Access Report

Maitland Gaol Redevelopment
MAIN WORKS
6-10 John Street
EAST MAITLAND NSW

For: Maitland City Council
Ref: PAA_23218

Figure 2 | Site Plan (in part)

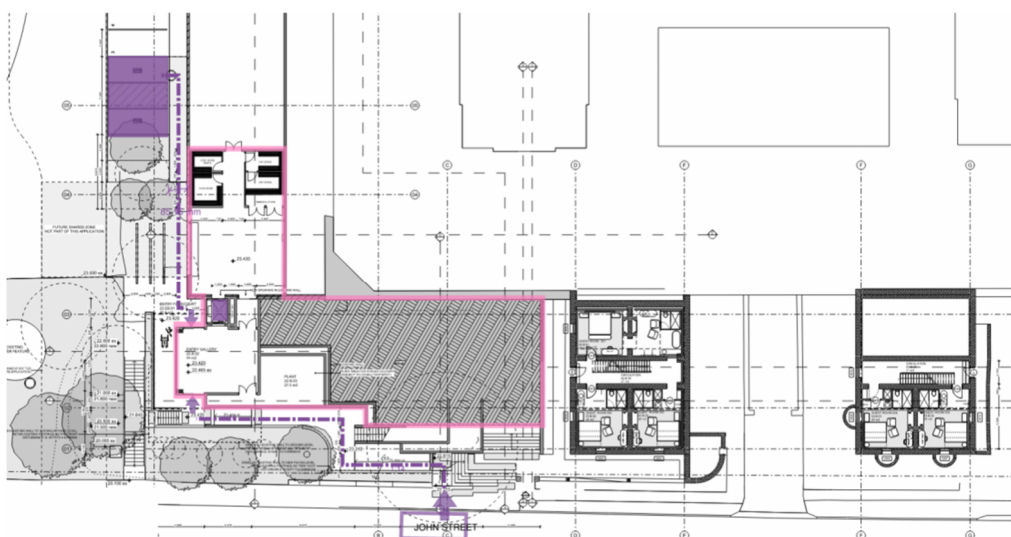
An accessible path of travel is provided to the building entrance from the allotment boundary along John Street. An accessible ramp will be provided.

As the street footpath along John Street, in its existing condition, does not facilitate an accessible path of travel having a gradient of approximately 1:11, modifications are proposed to provide an accessible drop-off area with an accessible link to the ramp.

An accessible path of travel is provided to the building entrance via a formed footpath. Site levels indicate that on-grade access is achievable.

Footpaths that form the approach to the building are a generally 1500mm wide as a minimum. Site levels indicate a level surface is achievable.

On grade parking is provided on the northern side of the building. Plans note a total of sixteen (16) carparking spaces, two (2) of which is nominated as accessible spaces. They are located closest to the building entrance.

Ensure that a bollard is provided to the shared space.

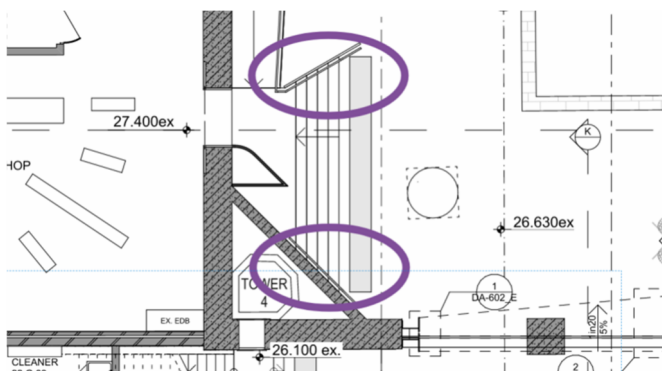
Stairs are provided throughout the building for access between various levels.

Overall configuration is generally in keeping with current legislation. Ensure provision of handrails with extensions both sides, tactile indicators top and bottom and contrasting non-slip nosing strips to treads.

Stairs to the B Wing Forecourt have splayed walls – ensure the handrails are installed parallel to the direction of travel to ensure user safety. A central (double) handrail may be an option for this stair.
